Red-throated Diver Implementation and Monitoring Plan (RTDIMP)

Description of Revisions			
Rev	Page	Section	Description
1			First draft for review by the RTDCSG
2	8-9; 14-25; 28-33	2; 4; 5; 6; & 8	Second draft following comments and feedback from RTDCSG
3	7; 16-20; 21-23; 28-29; & 30-31	2.3; 4.1.2.1; 4.1.4.1; 6.1 & 8	Third draft following comments and feedback from the RTDCSG
4	8-9 & 23	2.5 & 4.1.4.3	Fourth and final draft following final comments and feedback from the RTDCSG

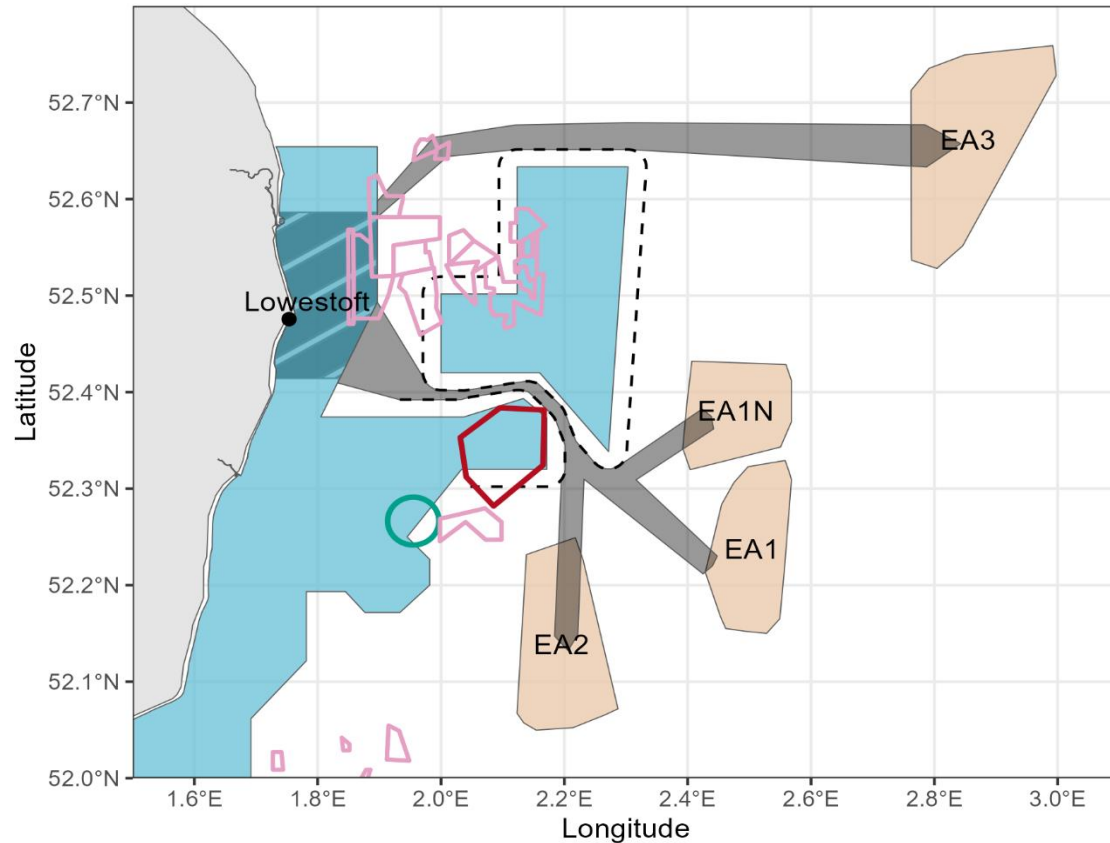
NE 3	Figure 3	<p>As noted in our meeting of 06 September 2024, the without prejudice material showed vessel routes as lines, whereas in the draft RTDIMP broad corridors have been used. Unless clarified, the risk here is that vessel movements could occur within 2km of the SPA and therefore cause disturbance to RTD within the SPA, undermining the purpose of the re-routing. We advise that the vessel corridor to the north should be set a minimum distance of 2km from the SPA boundary. Whilst we recognise that it is not possible to stay 2km</p>	<p>Figure 3 in Section 4.1.1. has been updated to show the proposed vessel re-routing that will be used for the compensation measure. The new route to the north of the OTE SPA is 2km from the SPA boundary. The route which passes between the two parts of the SPA has been optimised to reduce the residual impacts of vessel disturbance on the SPA as far as is practically possible by maintaining the maximum distance possible from the boundary, whilst also ensuring safety and adherence to COLREGs.</p>	<p>Natural England accepts that a consistent area-based approach is important, but it would also be useful to see not only the number of vessels that have deviated, but also the associated details, including the date, time and duration of such deviations, since RTD abundance and distribution shows temporal</p>

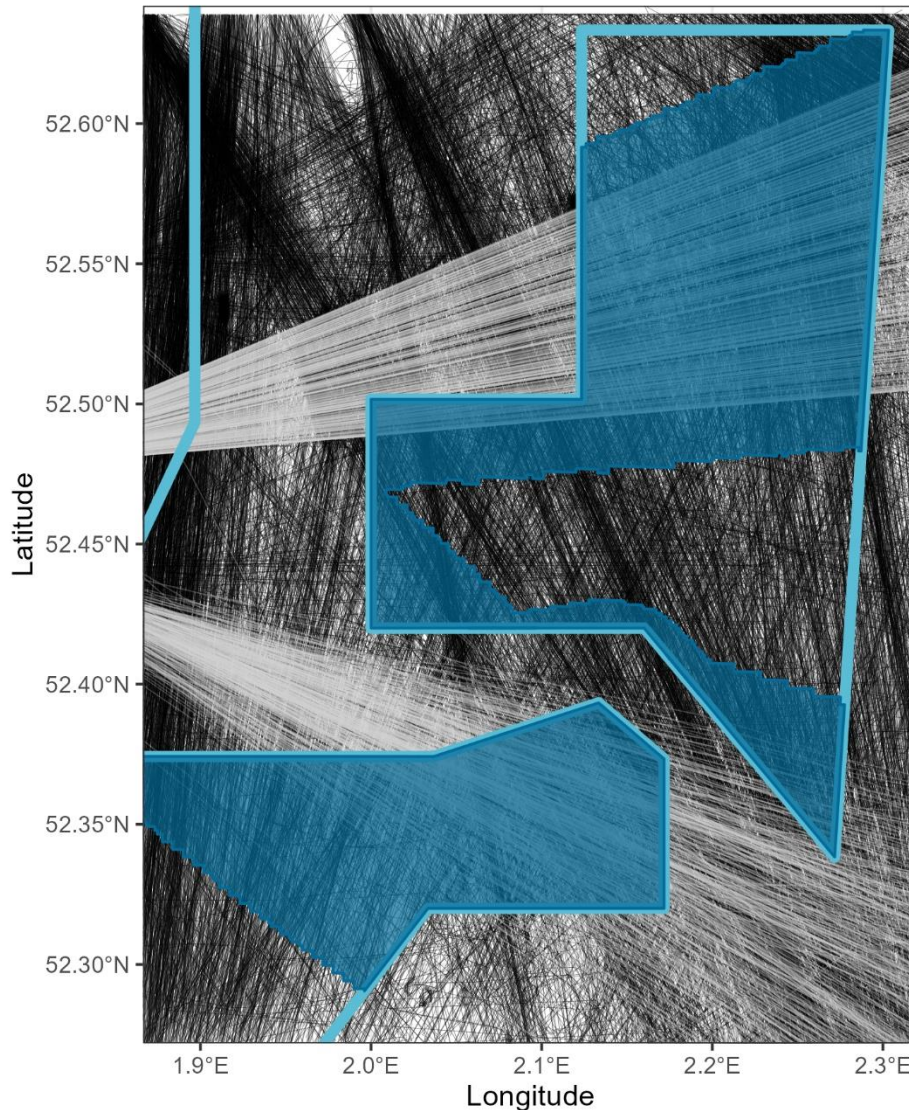
NE 5	3.1.4	This section is rather long and, for ease of future reference, could be broken into sub-headings.	This Section, which is now Section 4.1.4 has been broken down into sub sections for ease of reference.	CLOSED
NE 6	Figure 4	This Figure usefully highlights that there are multiple vessel movements through the area in question, only a proportion of which are (or will be) a result of SPR vessels. This means that if successful the rerouting will result in a reduction in the number of vessel movements but that it is far from clear whether the removal of these will make a meaningful difference to the level of disturbance that occurs, given the lengthy diver return time following vessel disturbance. Given the requirement to test the effectiveness of the measure in order to inform adaptive management, Natural England	See response to NE 3 regarding % vessel removal, monitoring and validation. Section 8 Adaptive Management of the updated version of the RTDIMP describes triggers/ thresholds for adaptive management based on monitoring and validating the vessel re-routing data.	CLOSED

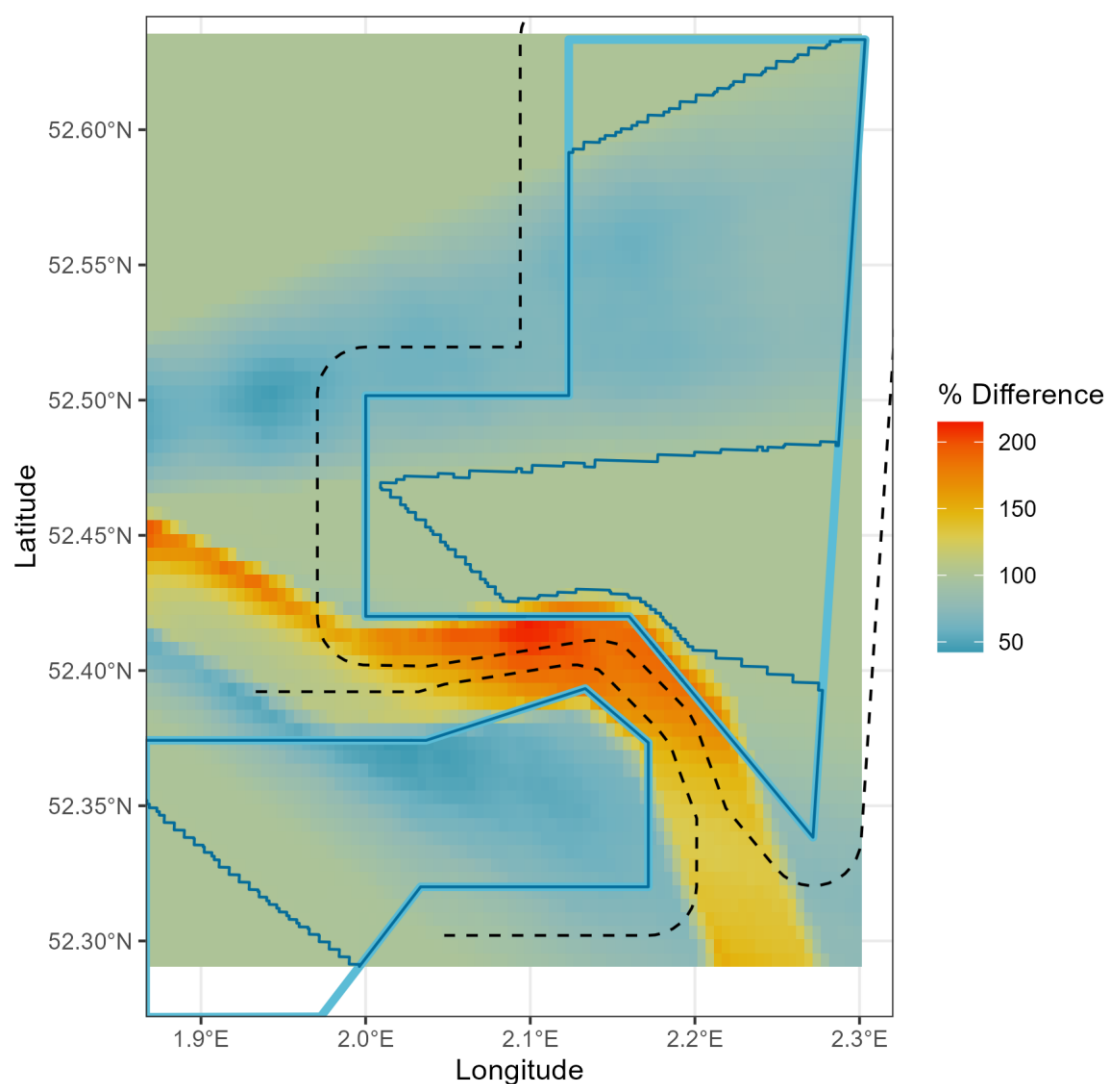
JNCC 2	Table 4	<p>What is included in the calculation of (e) OTE SPA affected area = 338.1km²? Is it just the area of the darker blue boundary in Figure 6, where the compensation is applied, or does it also account for those parts of the SPA where EA vessels will inevitably still impact the SPA, between the north and south sections? I.e. removing a bit of area where disturbance will still occur?</p> <p>In order to calculate the actual compensation ratio, will the same calculation be used as in Table 4, i.e. (d) Reduction in vessel activity * (e) OTE SPA affected area?</p> <p>It would be worth clarifying these in the RTDIMP.</p>	<p>JNCC identified an error in the original calculation where the area within the SPA affected by vessel traffic was based only on the existing traffic, and did not include a small area which would be within 2km of the re-routed traffic for EAOne. The analysis was revised to ensure this area was included and is now visible on the relevant figures and all numbers were recalculated. At the same time, it was evident that a small number of AIS vessel tracks to the west were clipped from the AIS data area, therefore additional AIS data was obtained to fill this area. The revised calculations take into account changes from both the original error and the additional AIS data.</p> <p>In the future, the actual compensation ratio will use the same calculation as in Table 4 based on actual AIS data.</p>	CLOSED
